FINAL
MONITORING REPORT
YEAR 1 (2018)
MUD LICK CREEK MITIGATION SITE

NCDMS Project No. 93482

RE: Mud Lick Creek Monitoring (DMS Project # 93482, Contract #7683)
Final MY1 (2019) Annual Monitoring Report

Axiom Environmental, Inc. (AXE) is pleased to provide you with three hard copies and a CD of digital files for the Final Mud Lick Creek Annual Monitoring Report. We received your comments via email on December 19, 2018 and have addressed them as follows:

FIGURE
2

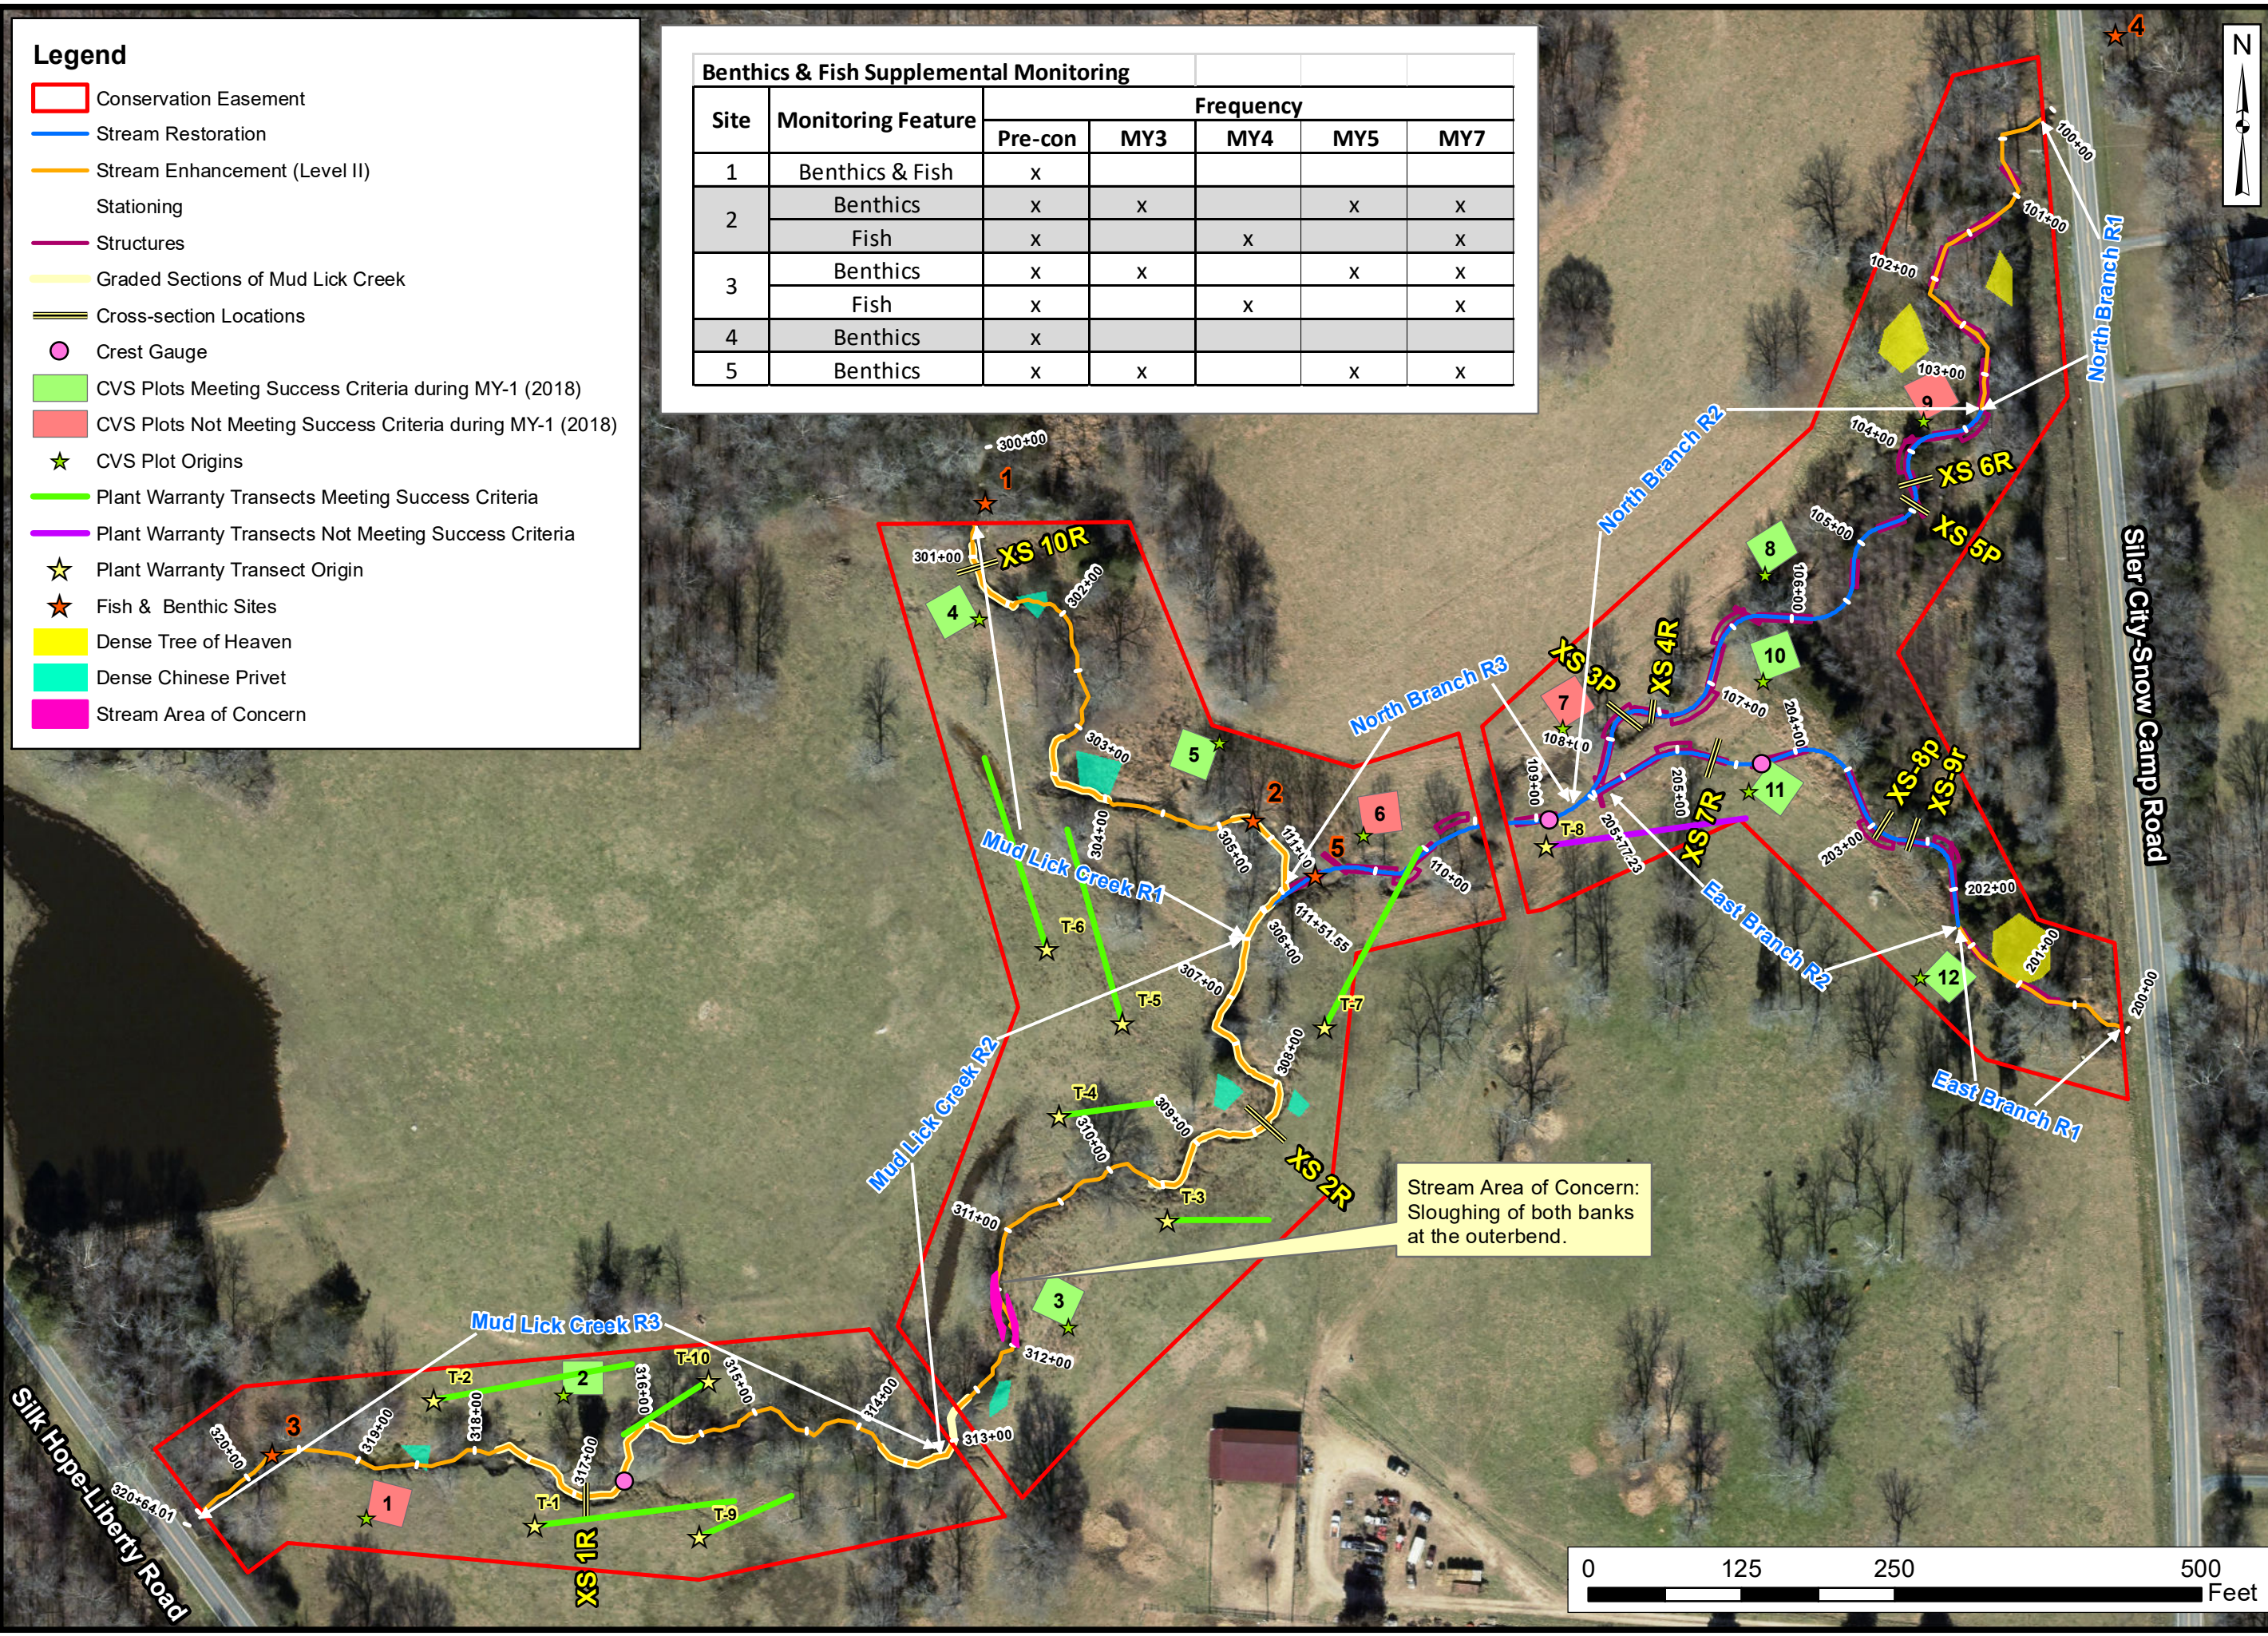
1. The digital data and drawings have been reviewed and determined to meet DMS requirements.
2. The pdf copy of the report has two (2) figure 2s, with one having more information shown. Please identify which is the correct figure and replace in the final hardcopy as well. *This has been addressed; the appropriate figure has been inserted into the final document.*

River Basin:	Cape Fear
Site Name	Mud Lick Creek
XS ID	XS - 7, Riffle (East Branch)
Drainage Area (sq mi):	0.27
Date:	12/6/2018
Field Crew:	Perkinson, Radecki

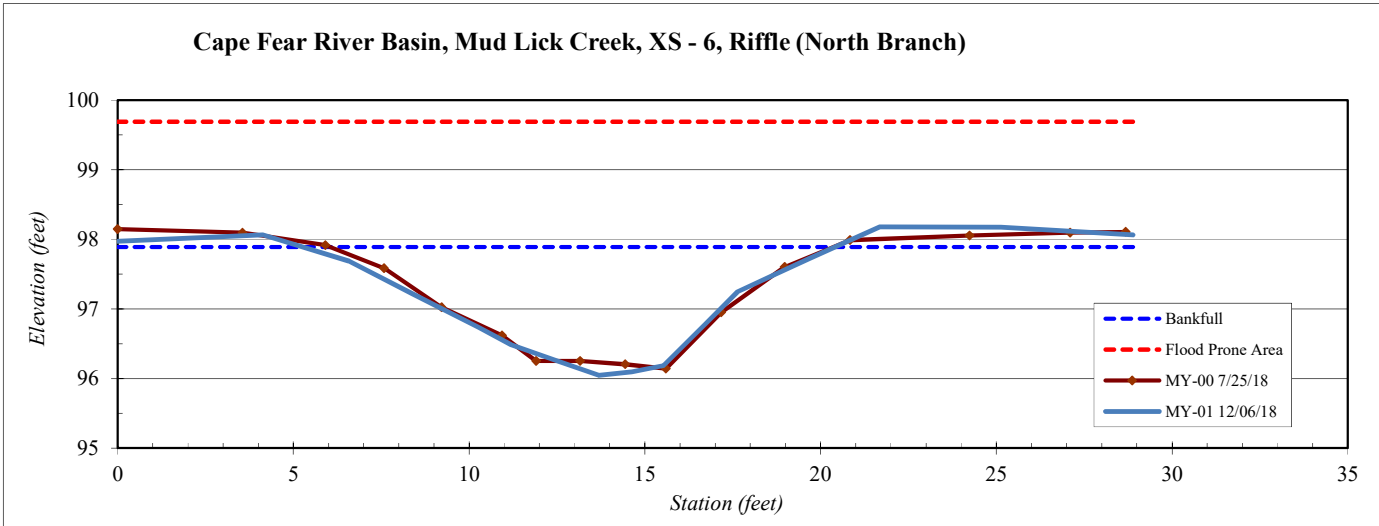
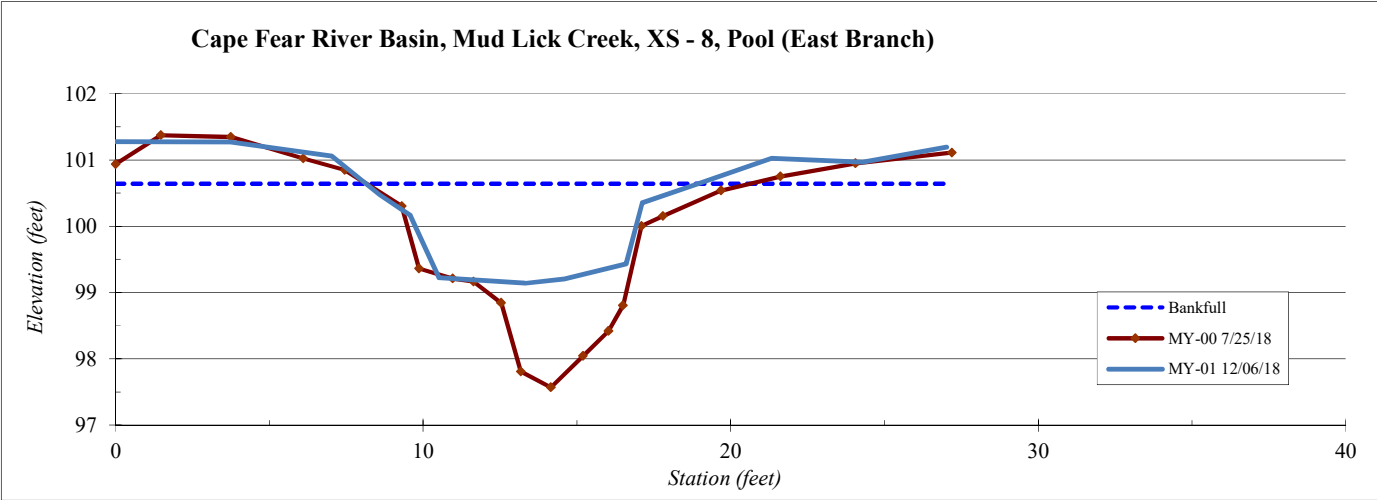
6. Appendix D, Table 11: Based upon the guidance prepared by the Technical Workgroup sent out by the IRT regarding the method to be used to calculate Bank Height Ratio (BHR), it appears that cross- sections 7 and 9 would be better candidates for a BHR of less than 1 given the reduction in cross- sectional area from MY0 to MY1. Please verify. *After reviewing cross-sectional data between As-built and Year 1 monitoring for Cross sections 7 and 9, it was determined that the BHR should remain at 1.0. This results from the bankfull cross-sectional area (using best fit methodology) remaining within the boundaries of the channel. Therefore, the low bank height also remains within the channel. The bankfull elevation did shift upwards on cross section 7 as the best fit method would require; however, so did the top of bank. If you compare cross-section 7 as-built with Year 1 the top of bank is reasonably situated in both cross-sections. If you would like to review the cross-sections together please let us know. However, we believe it is justifiable to report a bank height ratio of 1.0 for both cross sections.*
